PRODUCT CAMPAIGN BULLETIN

APPLICABILITY: 2002~03MY Subaru Impreza
SUBJECT: Left Front Seat Slide Rail Bolt

NUMBER: WWT-04
DATE: 08/2004

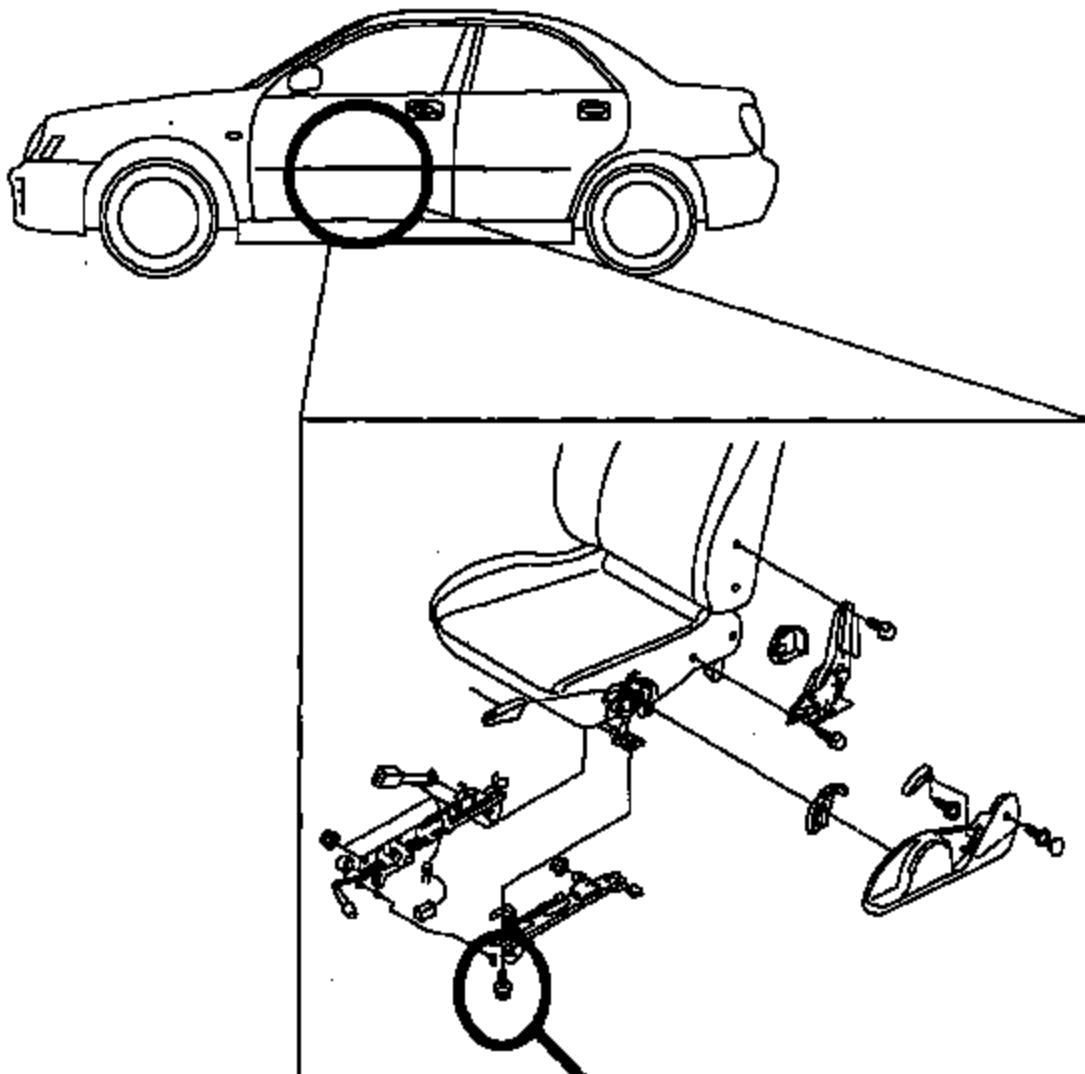
- 1) Open the driver's door fully.
- 2) Locate the bolt as shown in the illustration below.
- 3) Gain access to the bolt by positioning the seat at the 5th notch from the front on the slide rail. Ratchet the height adjustment to the upward position.
- 4) Remove the original bolt and install the new slide rail 12mm retention bolt & washer assembly with thread-locking compound. Torque to 18 ft-lb. (24.5Nm)

The original bolt should be replaced with a new bolt and washer assembly.

Note: In case the new bolt is hard to position, loosen the four front seat mounting bolts. Install the new bolt and retorque the seat mounting bolts to 39 ft-lb (53Nm).
